CITY OF PORTLAND, MAINE
PLANNING BOARD

Project Name:	Canal Plaza Hotel	Project ID:	2012-558
Address:	433 Fore Street	CBL:	32-I-40
Applicant:	Cow Plaza Hotel, LLC, Applicant		
Planner:	Nell Donaldson

PLANNING BOARD REPORT PORTLAND, MAINE

Canal Plaza Hotel
433 Fore Street
Level III Site Plan Review
2012-558
Cow Plaza Hotel, LLC, Applicant

Figure 4: Revised site plan, showing final configuration of building, service alley, porte cochere, and sidewalk

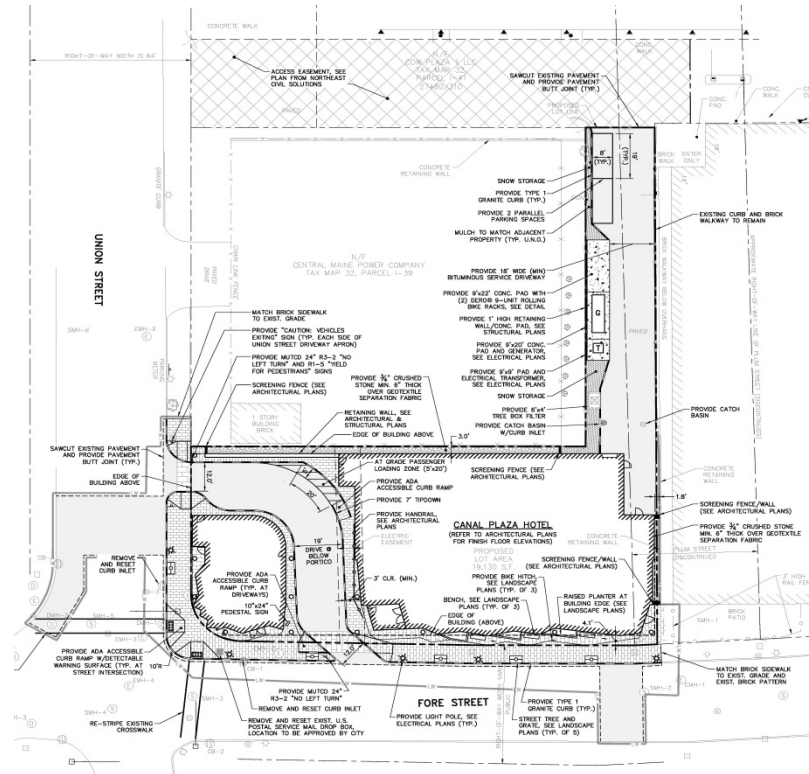
The applicant has requested a waiver from the 150’ separation requirement for the driveways in the porte cochere area (*See Technical Manual 1.7.2.7*). As proposed, the vehicular ingress via the porte cochere is 50’ from the intersection on Fore Street, and the egress is 75’ from the intersection on Union Street. Of this, Tom Errico notes,

The project does not meet City driveway corner clearance standards. Given the proposal for turn prohibitions and geometric design features, I support a waiver from the City’s Technical standard.

Since their original submittal, the applicant has redesigned the porte cochere to restrict left turn movements from Fore Street. The applicant also added a convex mirror and signs at the porte cochere to alert drivers to left turn restrictions and the pedestrian crossing. Mr. Errico writes,

The plans include installing a sign and I have no further comment. There was a comment about installing a "Do Not Enter" sign at the egress drive location on Union Street. The applicant should install the noted sign.

The applicant has revised the plan to include granite pavers for the driveway apron areas. The City finds this condition to be acceptable with the following conditions: 1) the applicant will be responsible for the maintenance of the granite paver aprons; and 2) the applicant shall provide documentation on existing examples of the proposed slip-resistant details for review and approval prior to construction.

The required driveway apron material for this area with brick sidewalks is asphalt. It is my understanding that the applicant would prefer not to use asphalt and has proposed using Jonesboro Granite. This is a change from the City's sidewalk material policy and may require Council approval. If it is determined that this material is to be allowed, and since the City does not keep Jonesboro granite in stock, I would recommend an agreement between the applicant and the City be drafted stating that maintenance of these sidewalk areas would be the responsibility of the applicant even if damaged inadvertently by City equipment. Also, since wet granite has resulted in slipping issues elsewhere in the City, can the applicant provide assurance this will be a non-slip surface?

Concerns regarding stacking at the porte cochere remain. The applicant has provided a letter from Commonwealth Hotels, LLC, the proposed hotel management company, which is included as *Attachment F* and describes how valet parking will be managed in the porte cochere. The letter predicts that one to five cars will use the porte cochere per half hour during the afternoon peak (during check-in), and that not more than one or two cars will actually be in the porte cochere at any point. During the morning peak (during check-out), the letter estimates a peak demand of one to four cars using the porte cochere per half hour and, again, not more than one or two cars at any point. The letter implies that four cars could feasibly fit in the porte cochere if necessary. Tom Errico writes,

The applicant has provided some general information on managing the drop-off area and the conclusion that it will not be problematic. I do not find the information to be sufficient for documenting specific details for avoiding potential back-up problems. I would suggest that a condition of approval be included that requires the applicant to provide specific details of the valet program and examples of existing hotel programs that address how they manage vehicle queuing problems.

The applicant has provided a graphic that illustrates a Single-Unit truck maneuvering into the loading dock without having to back from Union Street. I find this condition to be acceptable. The applicant has not provided information on how large truck deliveries will be accommodated. This issue is outstanding.

There is a serious concern on the part of our apparatus chief that 9'-6" is too close. He wants 10'-0" due to the Ford F series diesel ambulance chassis no longer being available and the potential need to move to a medium duty ambulance chassis such as the Navistar. If less than 13'-6" an approved sign will need to be installed and maintained indicating the established vertical clearance.

1. The applicant shall revise the final plans prior to the issuance of a building permit to include:
 - a) A “Do Not Enter” sign at the egress drive location on Union Street

8. The applicant shall provide a detailed plan for managing traffic in the porte cochere that includes sufficient staffing, 24-hours a day, to prevent stacking into the Fore Street sidewalk and street right-of-way and provide a plan for the handling of large truck deliveries for review and approval by the Planning Authority and the city’s Department of Public Services;

9. The applicant shall increase the clearance in the porte cochere to 10’, for review and approval by the city’s Fire Prevention Bureau;
10. A final lighting plan including photometric data and meeting relevant Technical Standards, which may include any proposed low intensity top floor wash or grazing lighting, shall be
